Designation: ~~D6241~~—22 D6241 – 22a

# Standard Test Method for Measuring Static Puncture Index Strength of Geotextiles and Geotextile-Related ~~Geosynthetic-Related~~ Products Using a 50 mm Probe<sup>1</sup>

FIG. 1 Probe

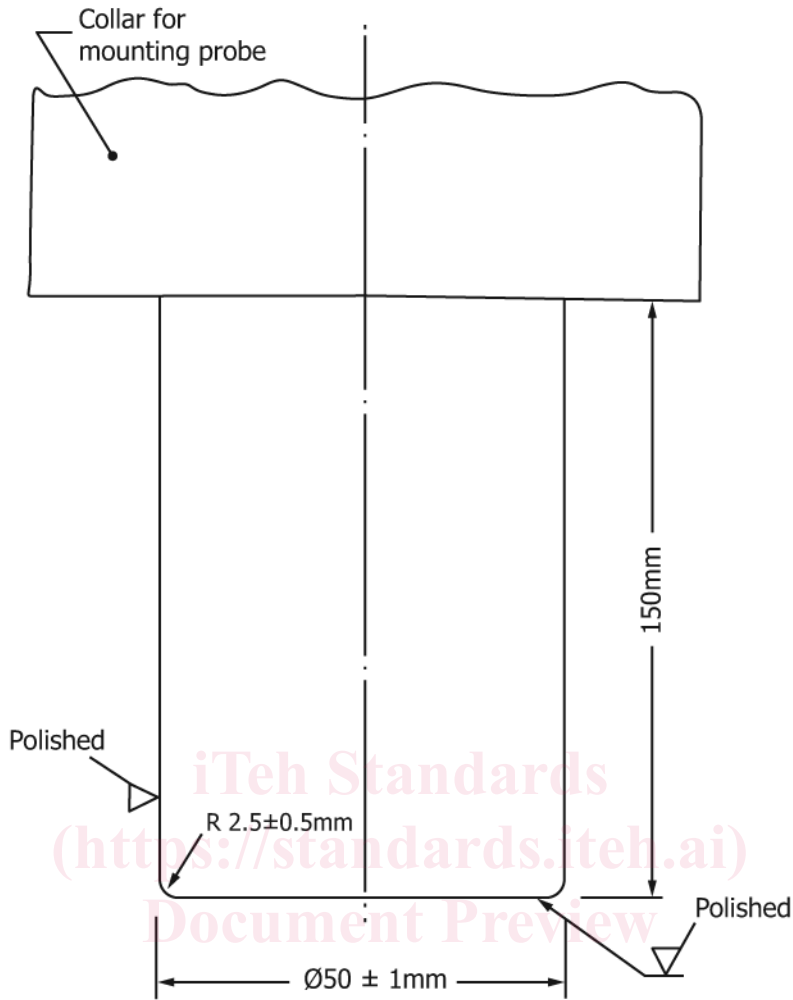
6.2 *Probe*—A ~~circular, 150 mm long polished steel loading plate~~ polished steel cylinder at least 150 mm long, with a flat diameter of  $50 \pm 1$  mm and a radial edge of  $2.5 \pm 0.5$  mm. See [Fig. 1](#).

FIG. 2 Example of Serrated Surfaces

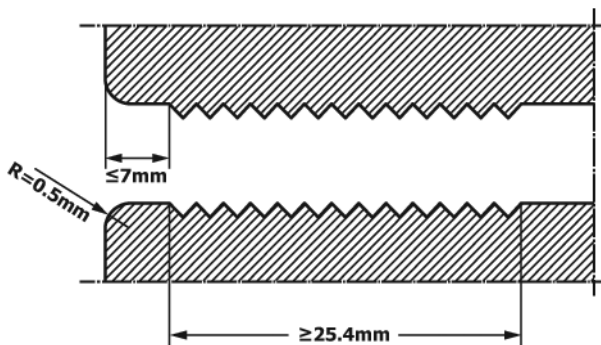
6.3 *Clamping Apparatus*, consisting of concentric plates with an internal diameter of 150 mm (5.9 in.), capable of clamping the ~~test specimen without slippage (limit slippage of test specimen to 5 mm);~~ specimen to prevent slippage. The external diameter is suggested to be 250 mm (9.8 in.). The diameter of the holes used for securing the ring clamp assemblage is suggested to be 11 mm (~~7/16 (7/16 in.) in.~~) and equally spaced at a diameter of 220 mm (8.7 in.). The clamping surfaces of these plates can consist of serrated plates, grooves with rubber O-rings, or coarse ~~the ring plates shall be machined to limit slippage to less than 5 mm; see Note 3 and paper bonded onto opposing surfaces.~~ It is suggested that 9.5 mm (~~3/8 (3/8 in.) in.~~) bolts be welded to the bottom plate so that the top plate can be placed over the bolts and nuts and easily tightened. A guide block may be used to help seat the material being clamped. Other clamps that eliminate slippage are acceptable. See [Figs. 2 and 2-34](#).
